Site Characterization/Remedial Investigation Reports/Risk Assessments
Philadelphia Refinery Complex
3144 Passyunk Avenue, Philadelphia, Pennsylvania

Remedial Investigation Report Addendum AOI-4
Remedial Investigation Report Addendum AOI-9

October 30, 2021

Written Comments by Clean Air Council

See 2021 Addendum Report (AOI-4), Figure 4-1e (Unconfined Aquifer Elevation April 2021).

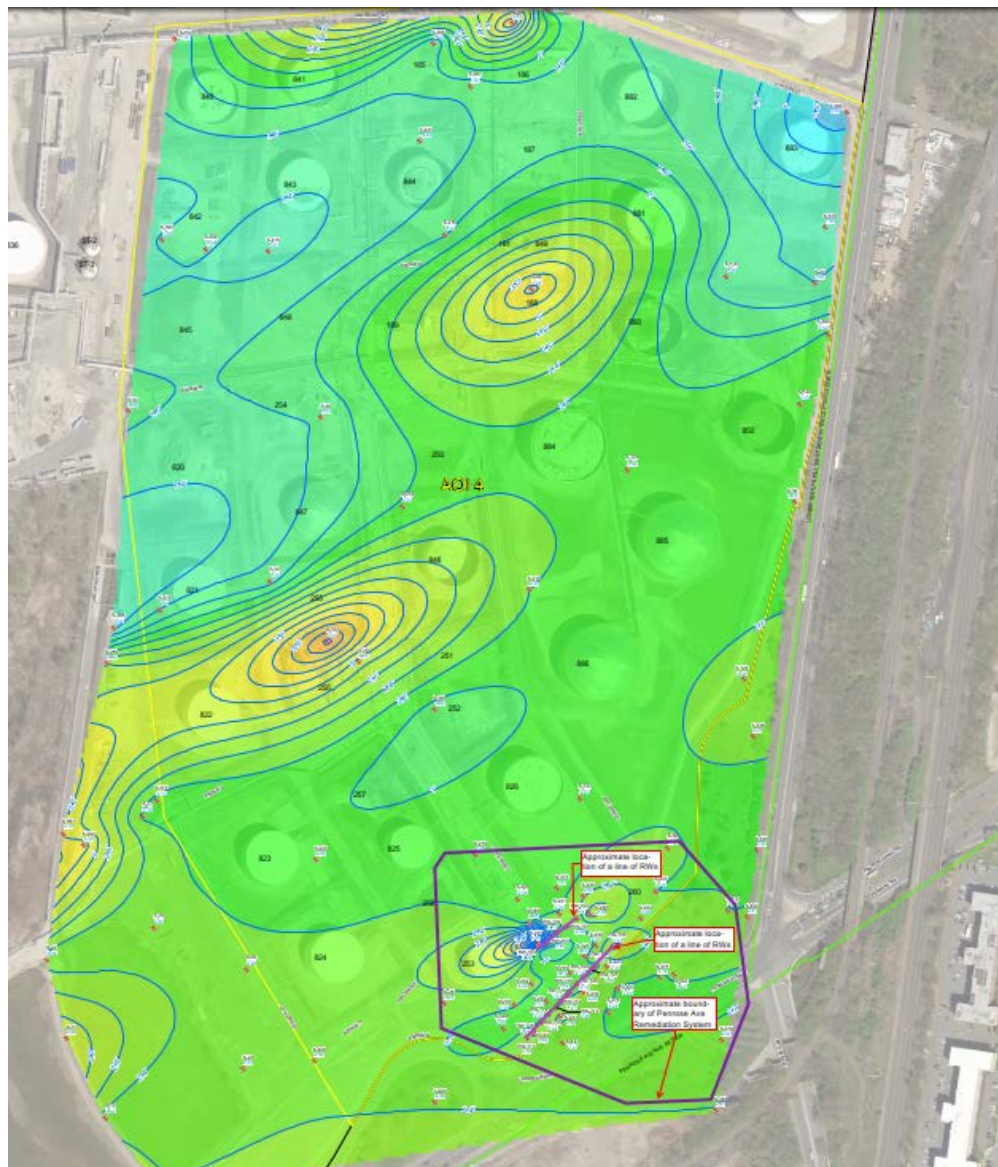
Furthermore, the Sunoco groundwater elevation mapping of the shallow water table shown on Figures 4-1a through 4-1e illustrate unexplained contours that may influence flow direction and contamination delineations on-site. An example is shown below in the snip of the northern portion of Figure 4-1e, showing a groundwater mound centering on shallow on-site wells (S-104 and S-96).

Cross referencing Figure 4-1e with the location of the Penrose remediation system and extraction points, it appears that potential groundwater mounds centering on shallow monitoring

wells (S-104, S-96, S-371) are not explained. Perhaps remedial systems, perching conditions, well construction or other factors can be attributed to the contours surrounding these wells taking a mounding shape. But this should be analyzed.

Such overlays may also help to explain the shapes of other areas contoured on Sunoco Figures 4-1a through 4-1e (perhaps with mounded, drawdown, convergence around sewers, or other unexplained shapes). An example of an overlay for the Penrose remediation system is shown below superimposed on Figure 4-1e:

See 2021 Addendum Report (AOI-4), pdf page 166 of 307, Figure 4-4 (Maximum Benzene Concentration Unconfined Aquifer, 2014-2021).

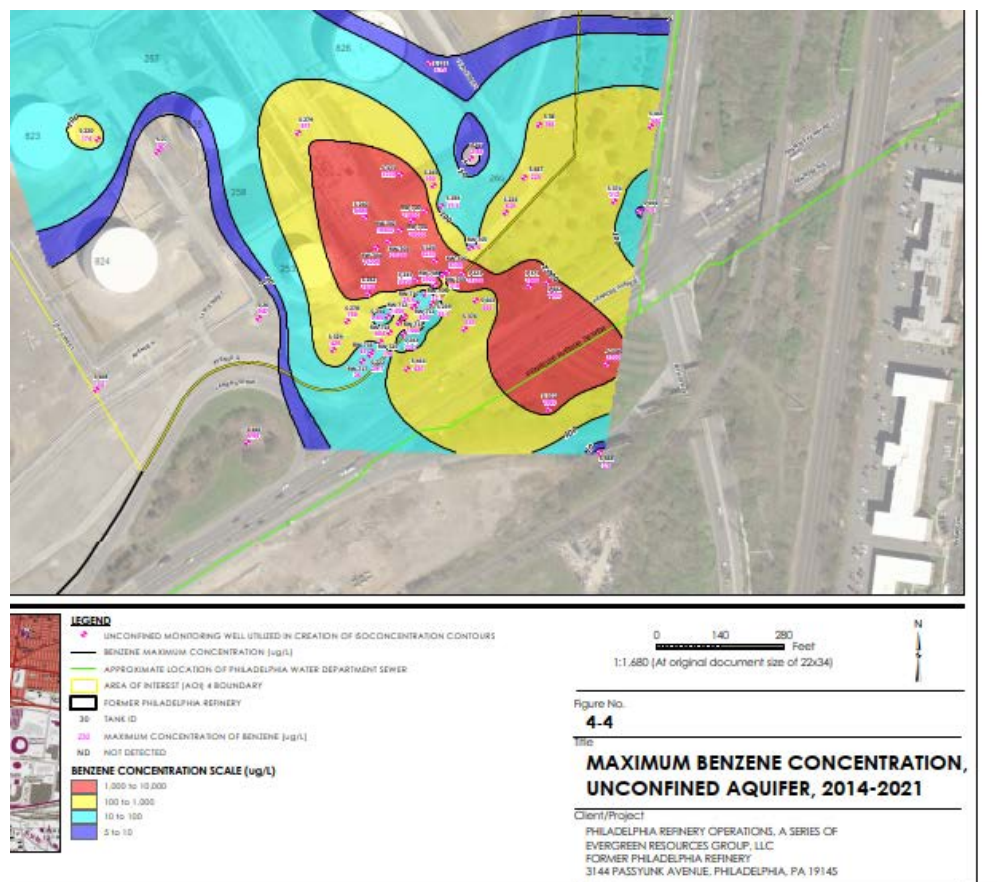
Disregarding the guidance document, Evergreen fails to thoroughly display the contamination data on its isoconcentration maps as well:

Sunoco's Figure 4-4 maximum benzene concentration unconfined aquifer 2014 - 2021 groups the highest benzene concentrations onto a single map. Mapping isoconcentration in this manner does not illustrate how the contamination plume has changed in time over the period 2014 through 2021.

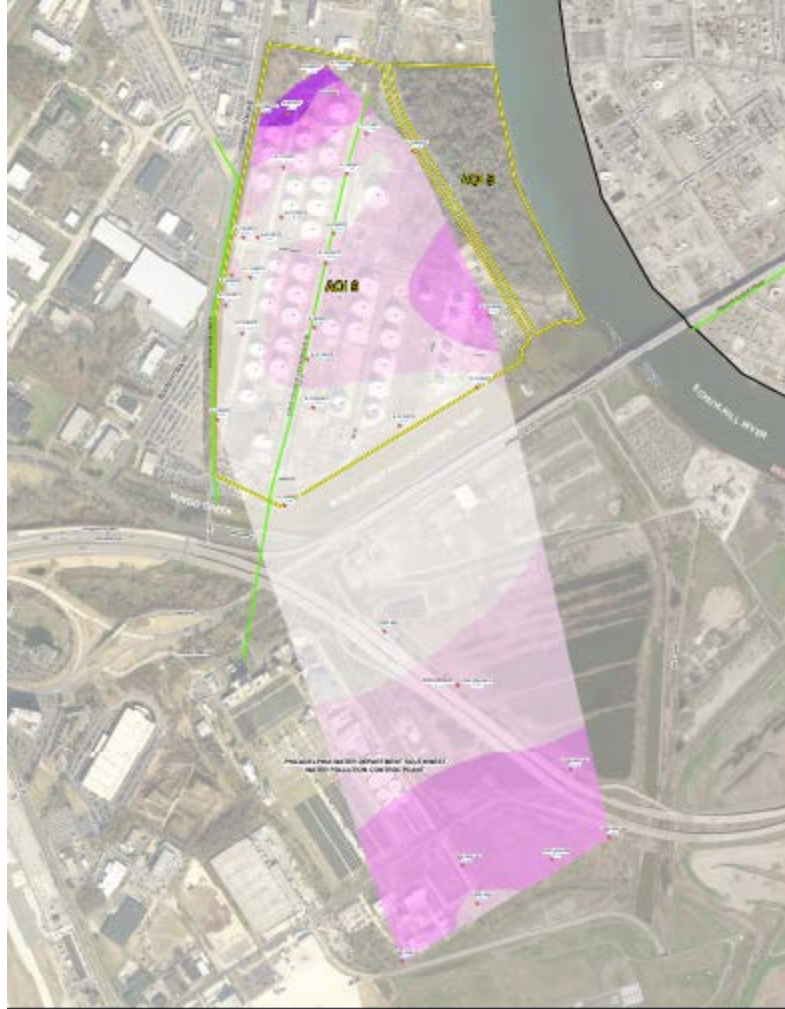
See id., Figure 4-2a (Unconfined Aquifer Elevation June 2018). Figure 4-2a illustrates groundwater elevations approximately 3,000 feet from the southern boundary of AOI-9. But on the western boundary, the farthest extent of groundwater gaging was a mere 100 feet beyond the boundary after the four newly installed unconfined aquifer wells were available. Sunoco should treat the mapping of groundwater at the western boundary as it has for the southern boundary.

See 2021 Addendum Report (AOI-9), Figure 4-5 Maximum Benzene Concentration Unconfined Aquifer, 2014-2021 (pdf page 127 of 307).

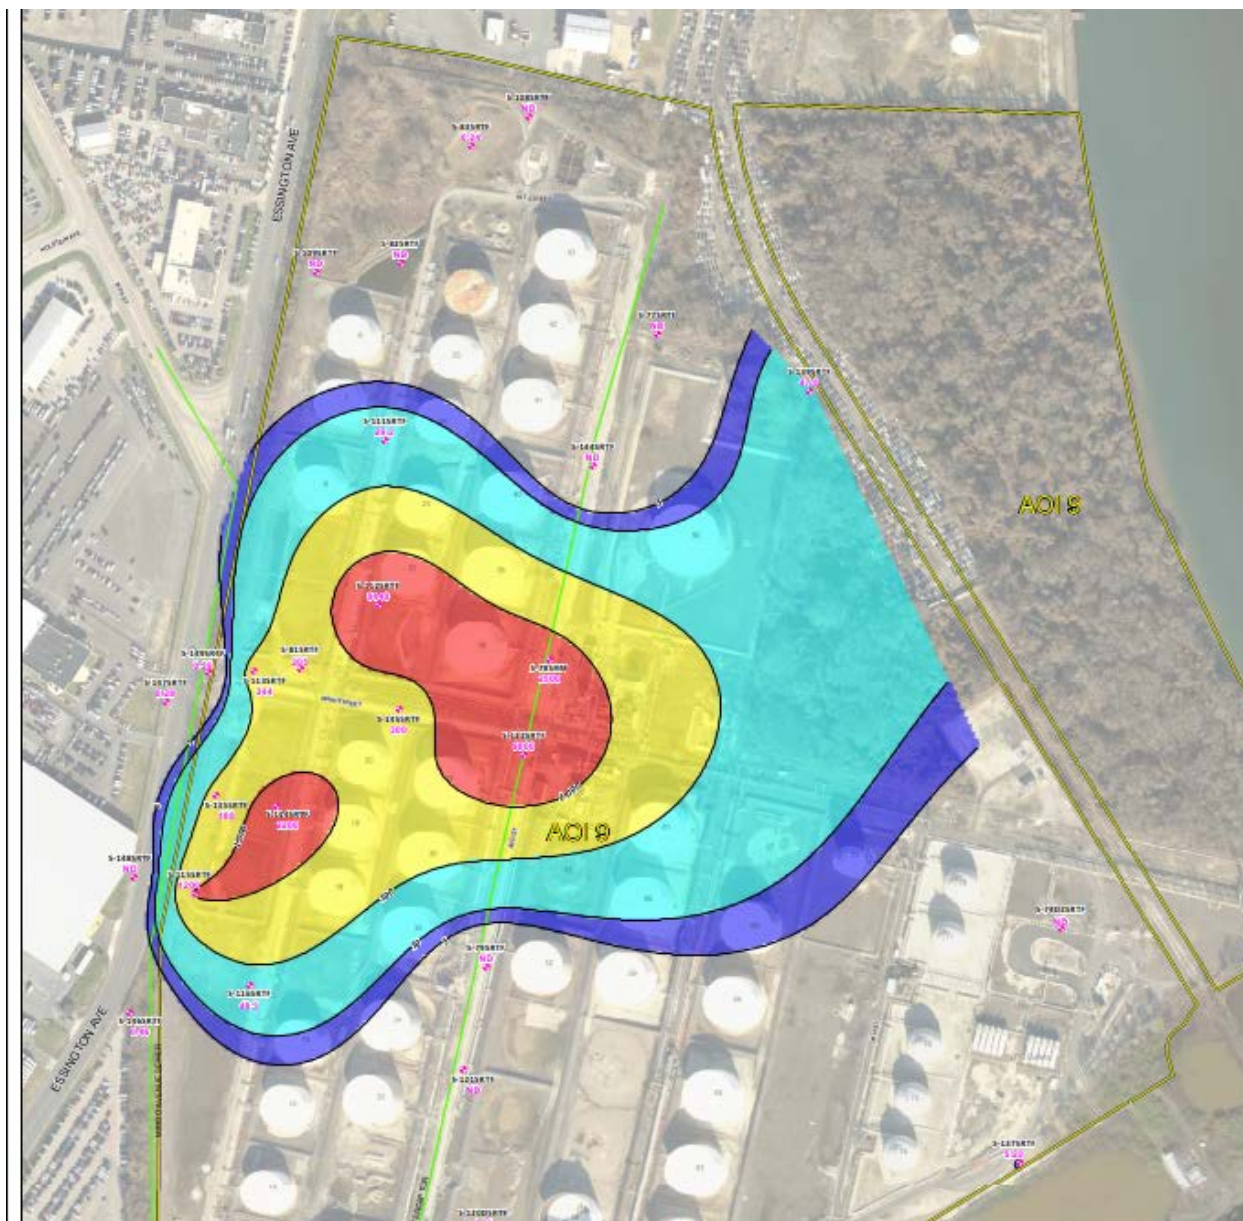
Evergreen's Figure 4-5 maximum benzene concentration unconfined aquifer 2014 - 2021 groups the highest benzene concentrations onto a single map. But mapping isoconcentration in this manner does not illustrate how the contamination plume has changed in time over the period 2014 through 2021:

See [2017 Report](#) (AOI-2), Figure 6 (Cross Section B-B'), pdf page 206 of 215; see also *id.*,

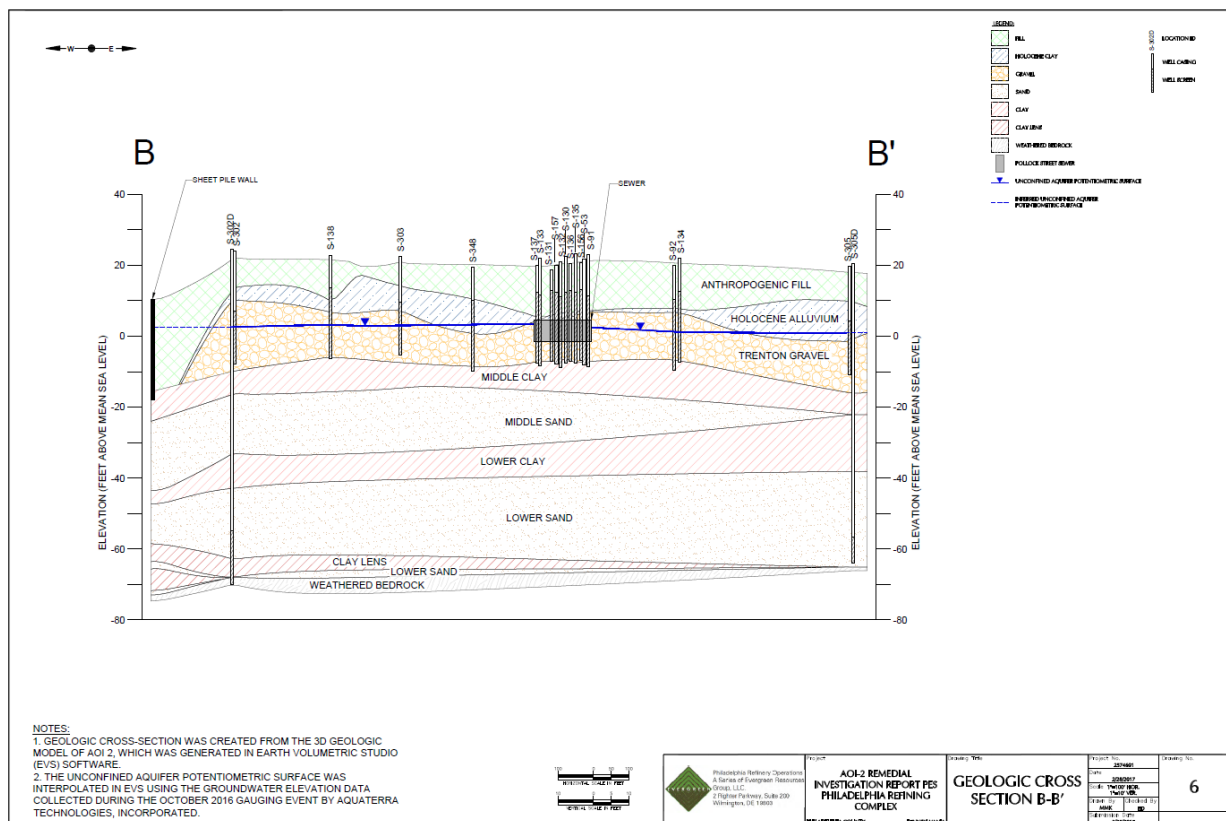
A geologic cross section for AOI-2 provides some information regarding the relative position of the sheet pile wall:

Figure 4 (Geologic Cross Section Location Plan), Figure 5 (Cross Section A-A'), According to the Figure above, the sheet pile appears to be lie even with the surface of the ground, and appears to have a depth of about 28 feet, extending into the clay by one or two feet. *See id.* Because the sheet pile wall appears to lie right on the Schuylkill River, Evergreen has an obligation to delineate whether contaminated groundwater is migrating into the river.

[2017 Report](#) (AOI-5), Figure 4 (Geologic Cross Section Location Plan).

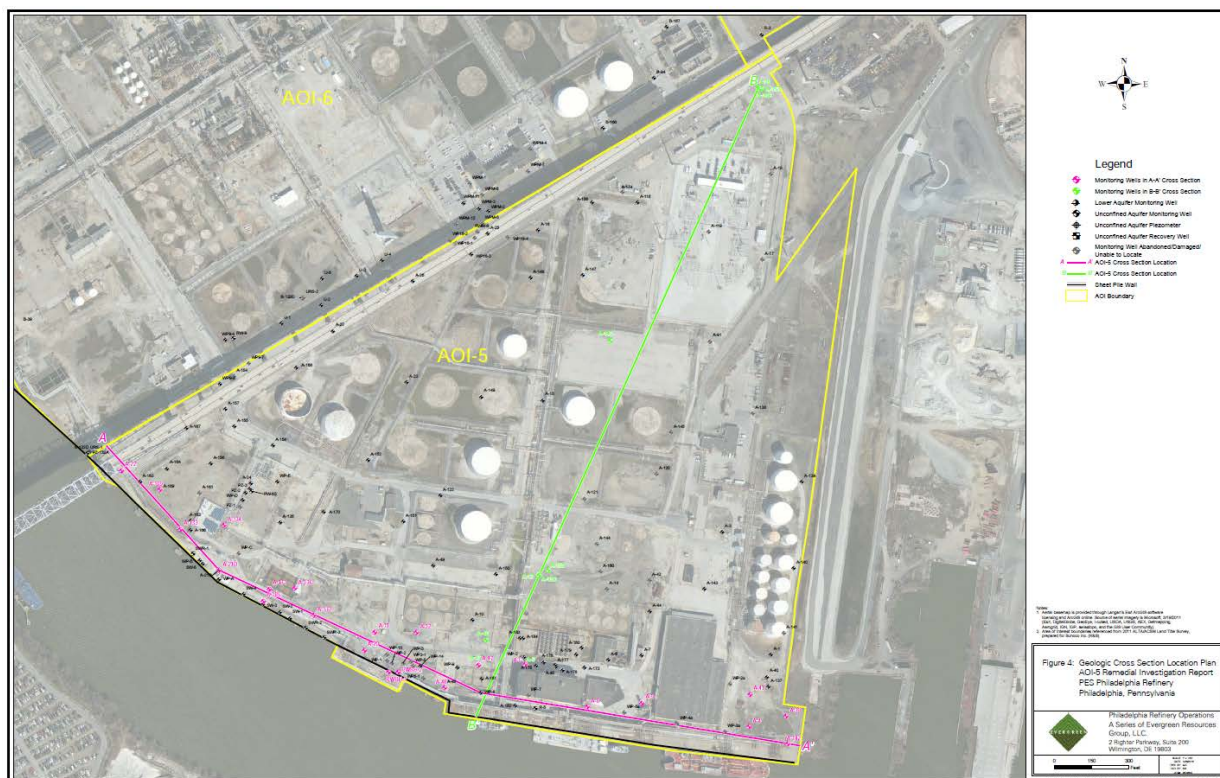
Instead, one must look to other evidence to ascertain the depth to the water table from the surface. Evergreen has provided geologic cross sections for all Areas of Interest. To illustrate with respect to AOI-5, the following Figure from the 2017 report identifies two cross sections -- an A-A' cross section generally running from west to east (in pink), and a B-B' cross section generally running from north to south (in green):

See *id.*, Figure 5A: Geologic Cross Section A-A'.

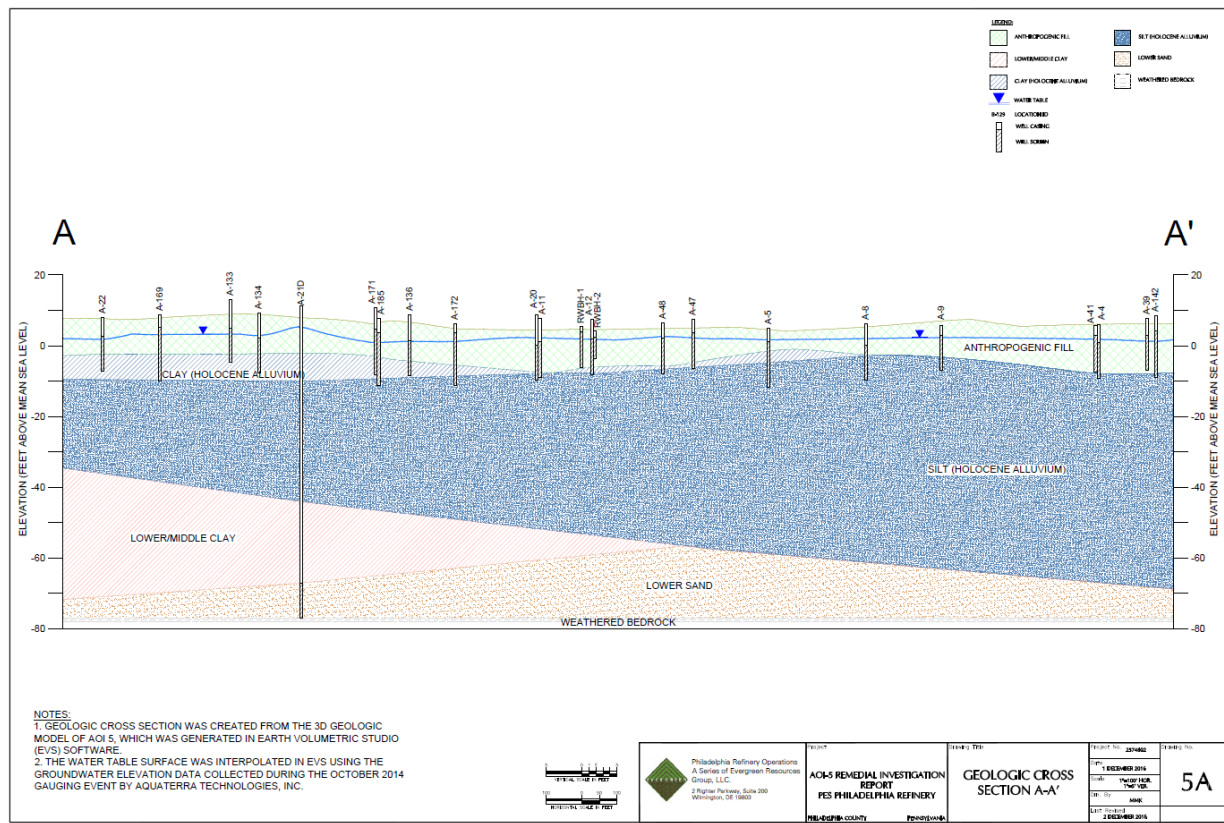
The following Figure displays a side view of cross section A-A', looking from the south toward the north. Throughout all of this cross section, the distance between the yellow line at the top (the surface) and the blue line below (the water table) is less than ten feet:

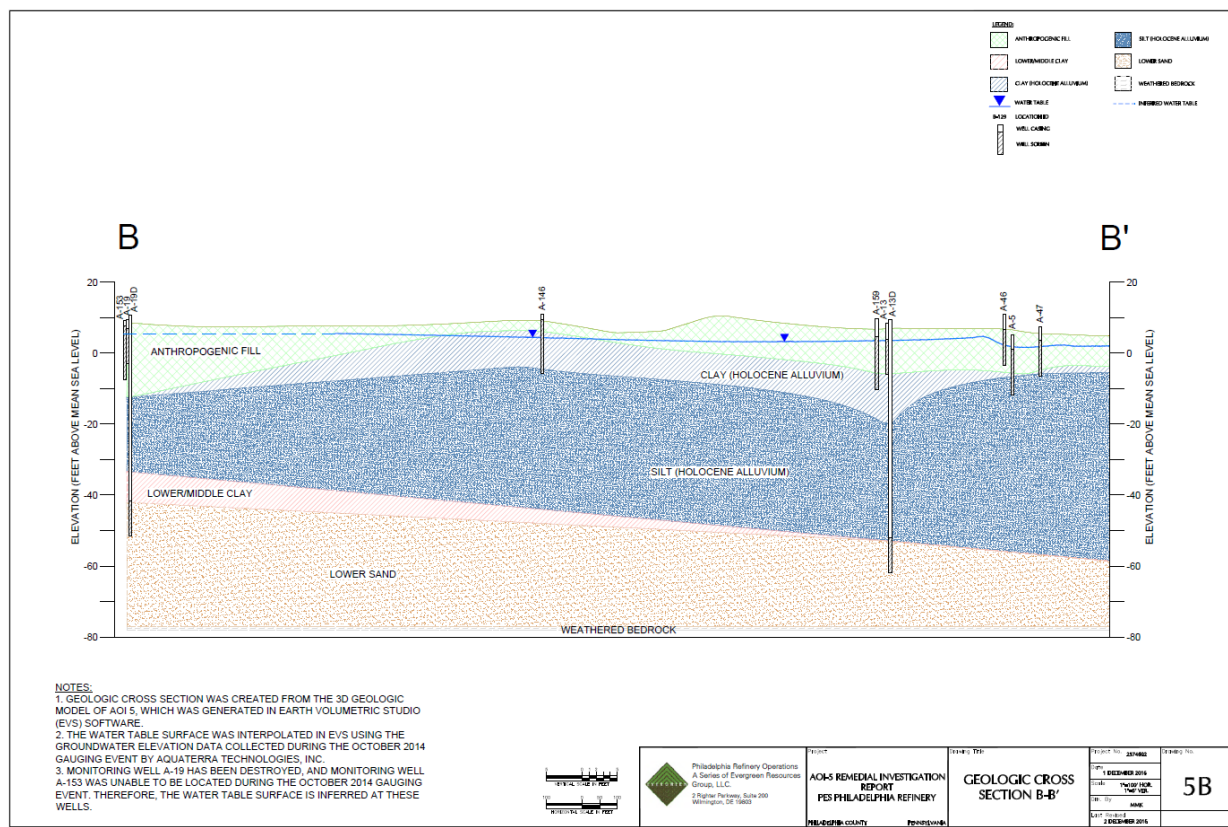
The other cross section B-B' tells a similar story. The following Figure displays a side view of this cross section, looking from the west toward the east. Throughout all the cross section, the distance between the yellow line at the top (the surface) and the blue line below (the water table) is less than ten feet:
